### PLANNING COMMISSION REGULAR DOCKET TUESDAY, February 14, 2012 – 5:30 P.M. CITY COUNCIL CHAMBERS

**APPLICATION FOR APPROVAL OF  
PRELIMINARY SITE PLAN**

ARLINGTON AND MILLMONT APARTMENTS  
 PREPARED FOR  
 PEAK CAMPUS DEVELOPMENT, LLC

**DEMOLITION PLAN - PHASE 2**  
 SHEET NUMBER  
 CD-102

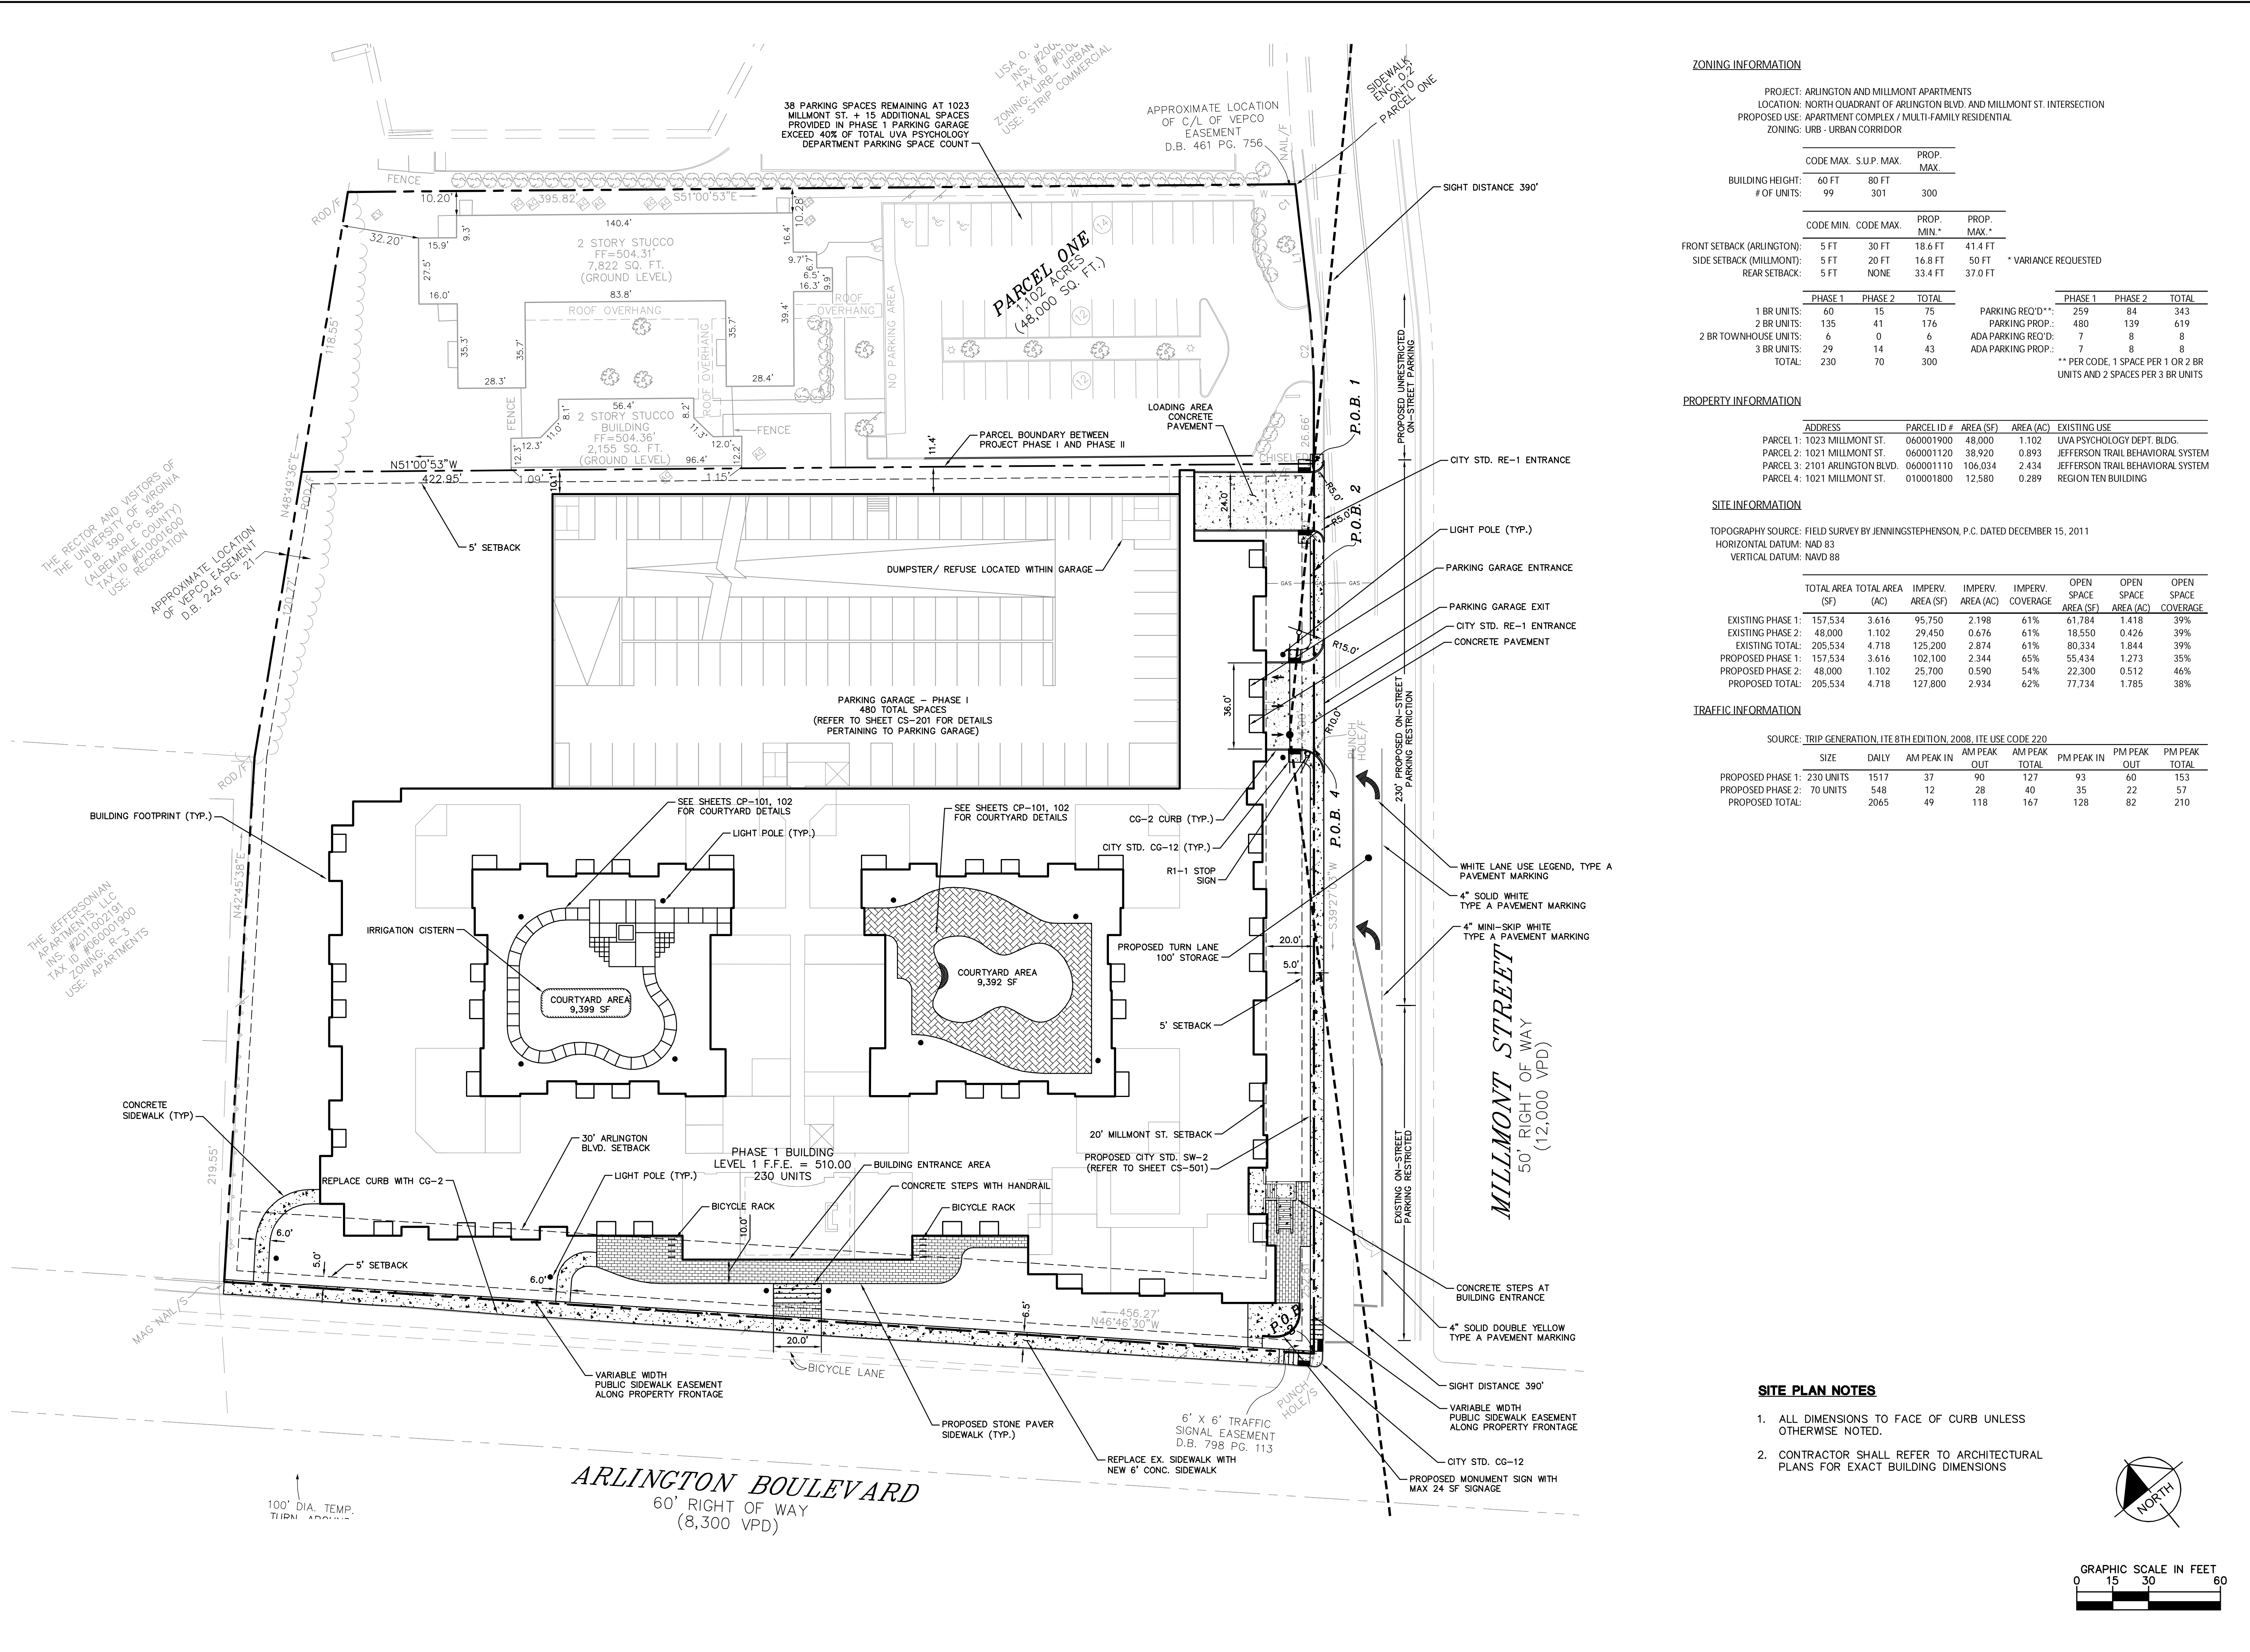
1. Demolition note #2 references sheet CS-502 for pavement repair detail. Please distinguish between permanent and temporary pavement repair on the plans.

**Response: All pavement repair shown on the plans will ultimately be a permanent repair, however during the course of construction there may be times when a temporary repair is necessary (i.e. work stoppage at end of day, temporary patch for pedestrian access, etc.). A note has been added to sheet CD-102 noting that all pavement repairs shall ultimately follow the permanent pavement repair detail on sheet CS-502 but to coordinate with City inspectors if a temporary repair is needed during construction.**

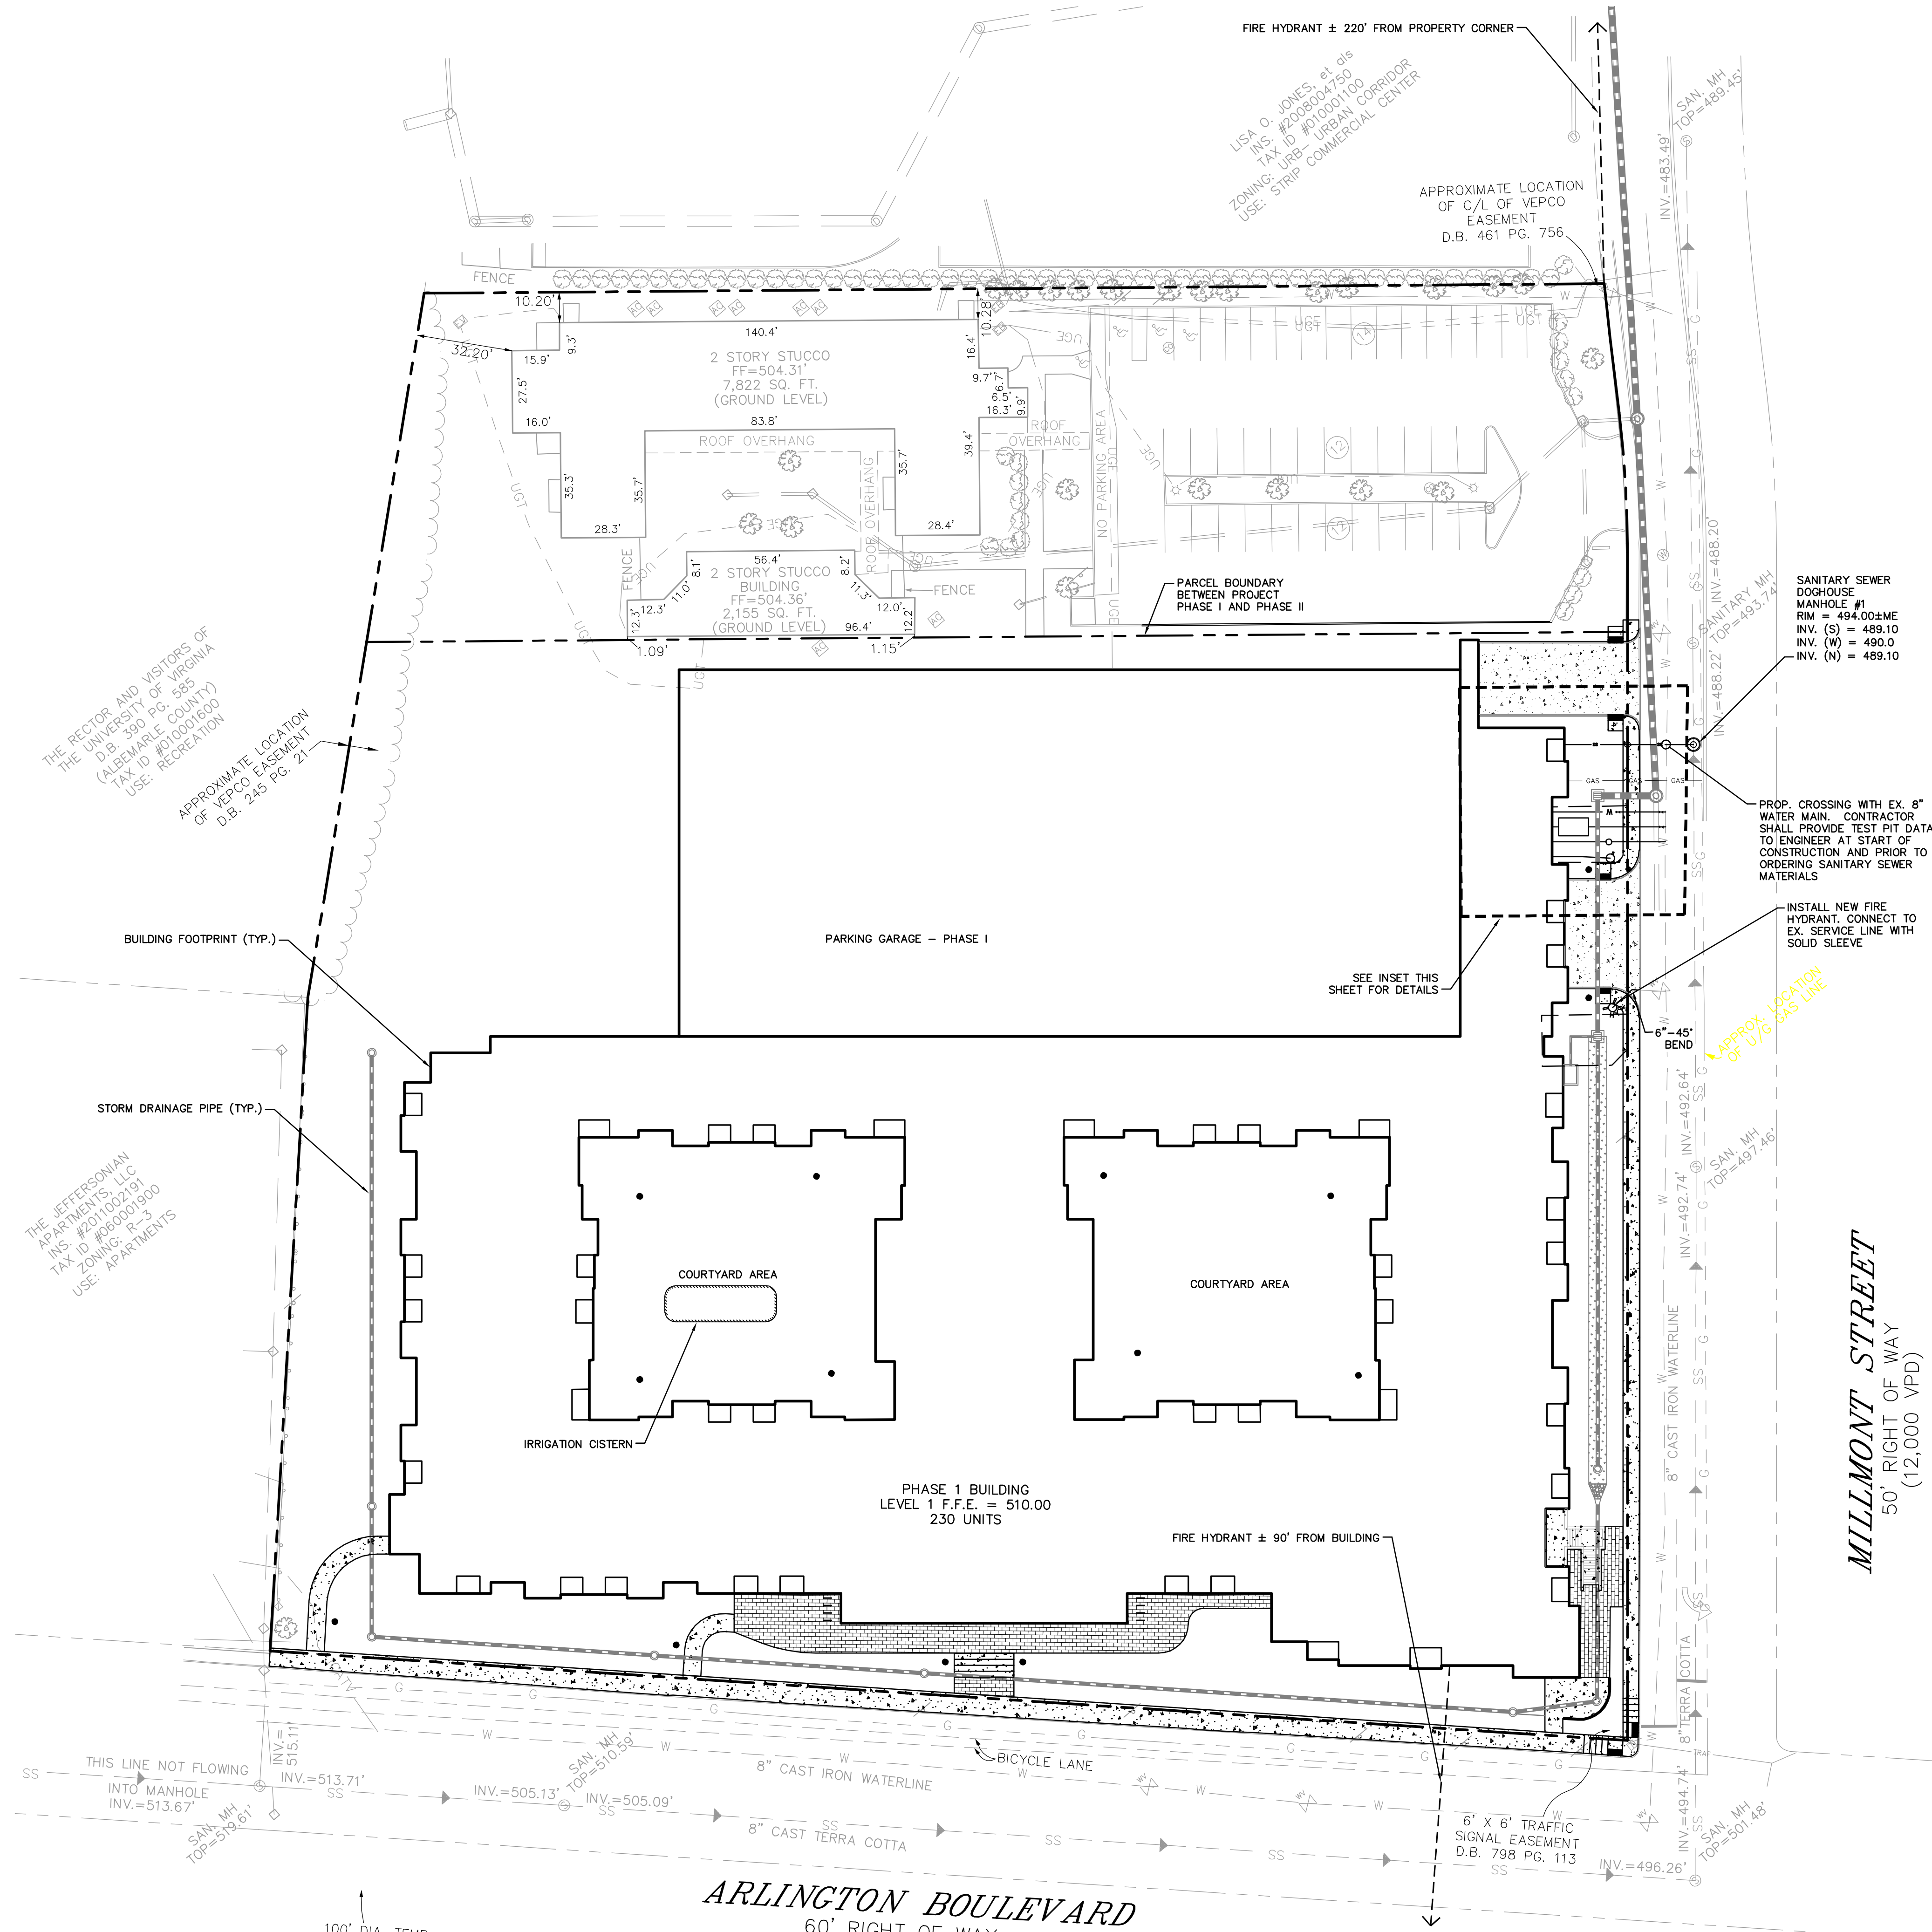
**Response: Water meter vault size has been labeled on sheet CU-101.**
8. Label the pipe size and material for the irrigation line. This should be 1" type-K copper.

**Response: The size and material of the irrigation line has been labeled in the notes section of sheet CU-101.**
9. I would recommend installing an RPZ on the domestic service as well. This may be a requirement in the next few years and a retrofit would be costly.

3. Gas utility is not shown on the plans for the proposed buildings. If gas is required, contact Ms. Irene Peterson at 434-970-3812.  
**Response: The proposed development intends to use natural gas service. Ms. Irene Peterson's contact information has been provided to the developer and an approximate location of the gas line connection has been added to sheet CU-101.**

**Response: 5' of separation has been provided at tapping locations and the requested note has been added to sheet CU-101.**
7. Label the size of the water meter vault.

**Response: An RPZ backflow preventer has been specified on the domestic service line and will be located within the building mechanical room. See note #5 on sheet CU-101.**

**Response: A new hydrant has been specified along with a solid sleeve on sheet CU-101.**
11. The City will maintain domestic waterlines and irrigation lines to the meter. C-900 PVC is not an acceptable material for City maintained lines. Please revise Note #2 to read "Domestic Water service pipe shall be C-900 pipe on the property side of the meter."

**Response: After review of the comment above, and further consultation with the project architect, the proposed sewer system and main connection for Phase 1 has been revised to outfall in one location. There is sufficient elevation difference across the building to accommodate one connection and this will simplify the proposed sewer system for the building. The revised layout is shown on sheet CU-101.**

- The submitted plan shall show the location and the distance to nearest fire hydrants to the project for both Arlington Blvd. and Millmont.  
**Response: Distances to the closest fire hydrants have been shown on sheet CU-101.**
